Job / File No	807/P07
Doc No	FN_0003-01
Date	20.10.2022, revision 01, 09.01.2023
Subject	Text for updated planning drawings
Note Author	JS

5th Quad Support Building

Updated Planning Drawings Summary

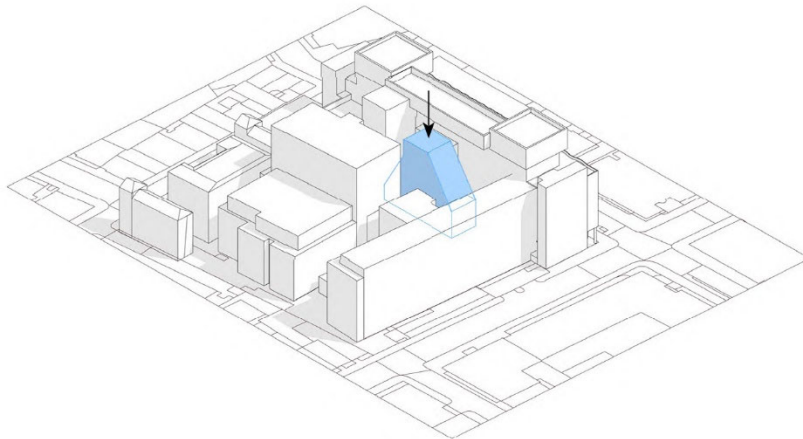
- A reduction of the proposed building height and extent.
- This reduction corresponds to a lessening of the impact of the scheme on the site and adjoining buildings.
- They result in an increased area of biodiversity compared to the previously submitted scheme.
- They result in an increased area of on-site renewable energy generation compared to the previously submitted scheme.

5th Quad Support Building as submitted 13.10.2021 (excluding PVs).

5th Quad Support Building as per updated drawings.

5th Quad Support Building overall massing as submitted 13.10.2021.

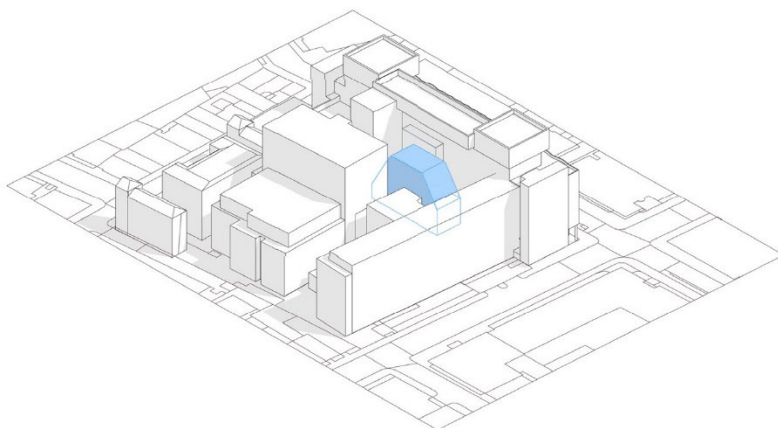
1. Removal of Level 5

The Sainsbury Welcome Centre undertook a review of their operational requirements and concluded that a 5th floor was surplus to requirements for the 5th Quad Support Building and more efficient layout could be utilised. The removal of this floor results in the following:

- A reduction in the overall height of the building from +56.025m (AOD) taken from the top of the balustrade to 51.155m (AOD) at the equivalent point.
- A reduction in the overall GIA of the proposed building from 905m² to 804m².

- c) The removal of a maintenance bridge link from level 6, this removes the impact on the existing building façade at this level.
- d) An increase in the green roof area of the building resulting in an increase in the on-site biodiversity compared to the previously submitted scheme.
- e) An increase in the area of on-site solar panels for on-site renewable energy generation compared to the previously submitted scheme.
- f) A minor realignment of the internal floor levels at levels 1-4 to accommodate additional raised access floor zones.
- g) The retention of views from level 5 of the existing SWC building.

5th Quad Support Building reduced massing as described in the updated drawings (removing Level 5).

5th Quad Support Building South Façade as submitted 13.10.2021.

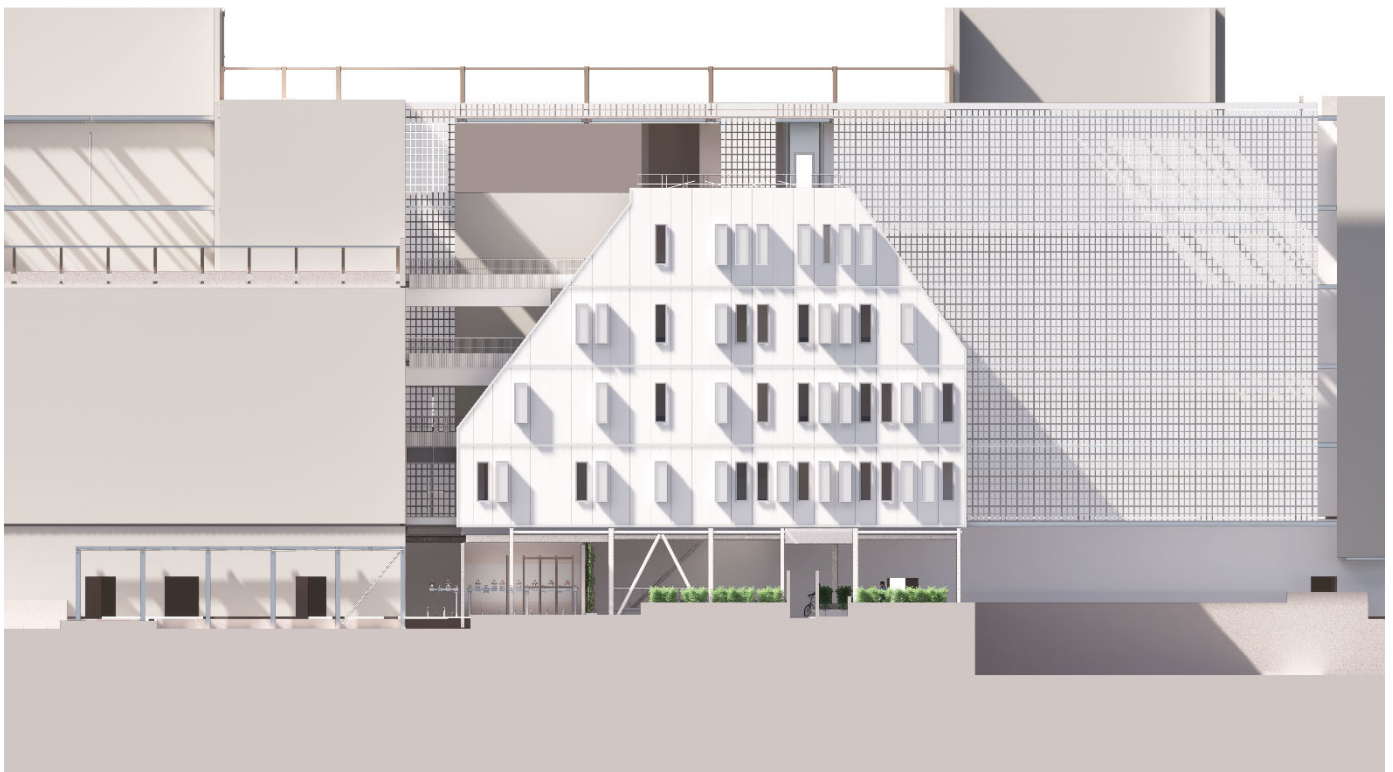
South Façade:

- a) In General:
 - The depth of the air vent profiles has increased by 150 mm.
- b) Level 4:
 - The relocation of two windows to match the internal plan reconfiguration. No addition or reduction of windows is proposed.

- The reduction of one air vent, and the relocation of three air vents.
- c) Level 3:
 - The reduction of one air vent, and the relocation of one air vent.
- d) Level 2:
 - The reduction of two air vents.
- e) Level 1:
 - The relocation of two air vents.
 - The omission of visible structural bracing on the façade.

5th Quad Support Building South Façade as described on the updated drawings (removing Level 5).
